<b>Title - Sujet</b> Mezzanine	
<b>Solicitation No. - N° de l'invitation</b> F3748-20BT01/A	<b>Amendment No. - N° modif.</b> 001
<b>Client Reference No. - N° de référence du client</b> F3748-20BT01	<b>Date</b> 2020-12-23
<b>GETS Reference No. - N° de référence de SEAG</b> PW-SMTA-170-15972	
<b>File No. - N° de dossier</b> MTA-0-43182 (170)	<b>CCC No./N° CCC - FMS No./N° VME</b>
<b>Solicitation Closes - L'invitation prend fin</b> <b>at - à 02:00 PM</b> Eastern Standard Time EST <b>on - le 2021-01-14</b> Heure Normale du l'Est HNE	
<b>F.O.B. - F.A.B.</b> Specified Herein - Précisé dans les présentes <b>Plant-Usine:</b> <input type="checkbox"/> <b>Destination:</b> <input type="checkbox"/> <b>Other-Autre:</b> <input checked="" type="checkbox"/>	
<b>Address Enquiries to: - Adresser toutes questions à:</b> Cimpan, Cristina	<b>Buyer Id - Id de l'acheteur</b> mta170
<b>Telephone No. - N° de téléphone</b> (514) 604-3855 ( )	<b>FAX No. - N° de FAX</b> ( ) -

## AMENDMENT 001

This amendment aims to announce a **MANDATORY SITE VISIT** on **Thursday, January 7, 2021.**

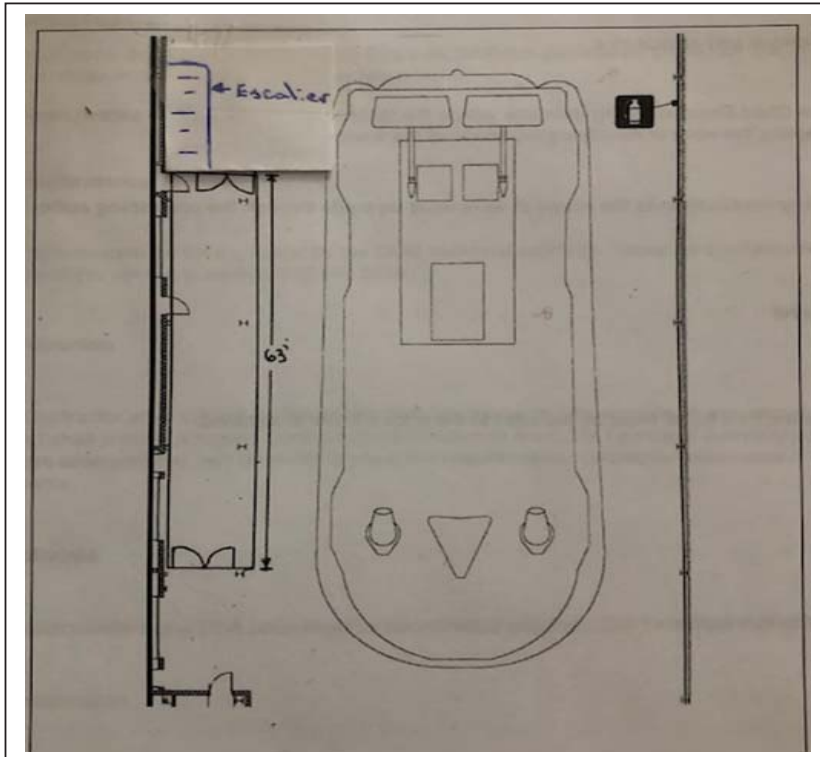
**Q2 :** It is your responsibility to provide us with the thickness of the concrete floor. Confirm that the floor is not of the radiant type.

**A2 :** No, the floor is not a radiant type and it is 250 millimeters thick.

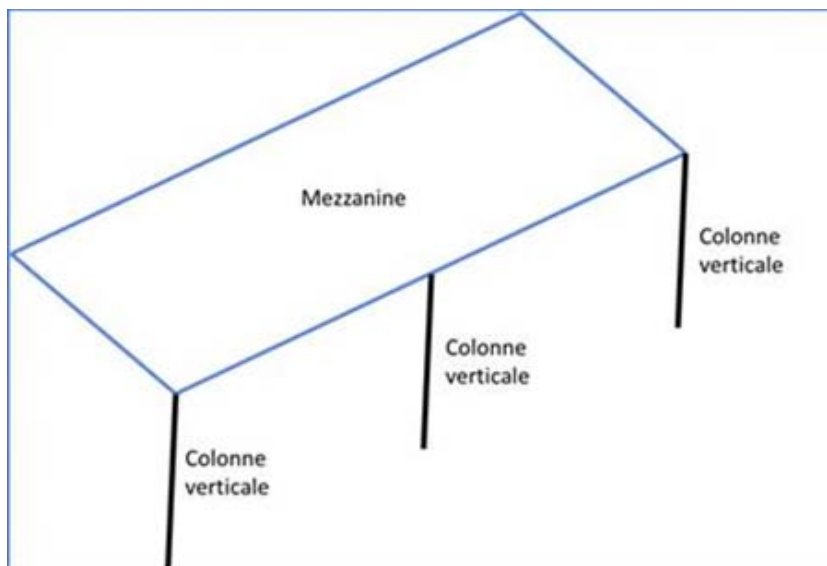
**Q16 :** Is there a total of 63 'of guardrails?

**A16 :** There should be guardrails on all 4 sides.

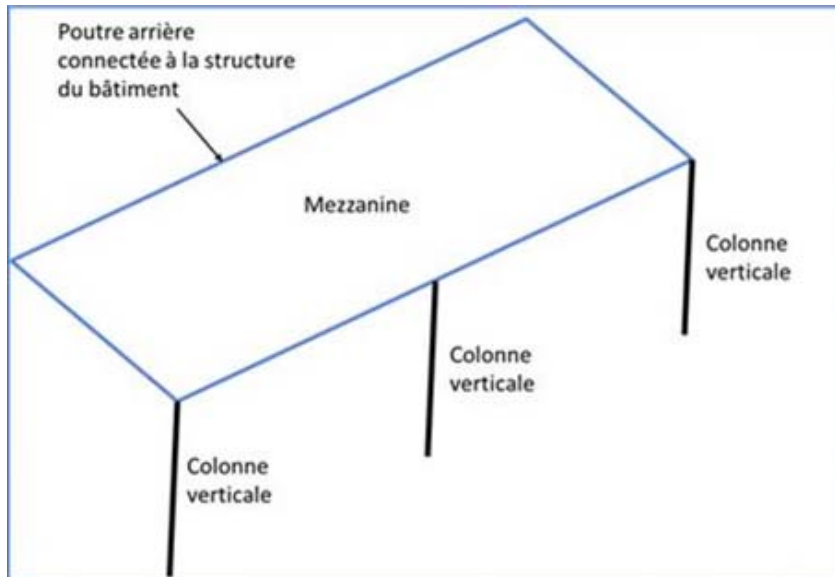
**Q20 :** Where are the brackets located on the building walls for the rear mezzanine beam?

**A20 :** The mezzanine must be of the self-supporting and cannot under any circumstances use existing structures for its support.
